Campaign No. 2021070027

Version 3.0

SUBJECT: **Model 907 Sprinter, Model Year 2019
Software Update**

D54.21-A036-76

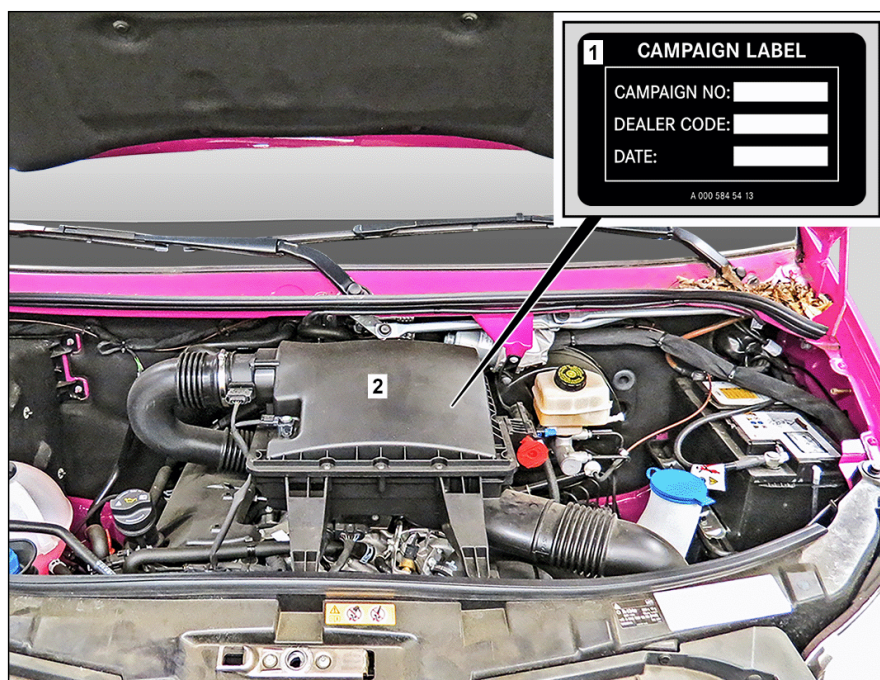
4	Update software for CDI control unit (N3/28 – Engine electronics 'CDI61NFZ' for combustion engine 'OM642' (CDI)).	<p> It is absolutely essential to precisely follow the operation steps as described in the vehicle diagnosis system.</p> <p> To do this, select the following menu items: Control units view → N3/28 – Engine electronics 'CDI61NFZ' for combustion engine 'OM642' (CDI) → Special procedures → Service measure "Exhaust gas aftertreatment"</p>	
5	Disconnect diagnostic system.		AD00.00-D-2000-06TS
6	Remove charger from vehicle.		AR54.10-D-1127TS
7	Fill out campaign label (1) and attach to air filter housing (2).	<p>Only applies for vehicles in State of California.</p> <p> Bonding surface must be absolutely free of dust and grease. Otherwise, a sufficient degree of adhesion cannot be assured.</p> <p> To do so, enter 6-digit campaign number, dealer code and date. Cleaner</p>	BR00.45-Z-1025-04A

8	Fill out certificate and hand over to customer.	<p>Only applies for vehicles in State of California.</p> <p> Apply number from campaign label (1).</p>
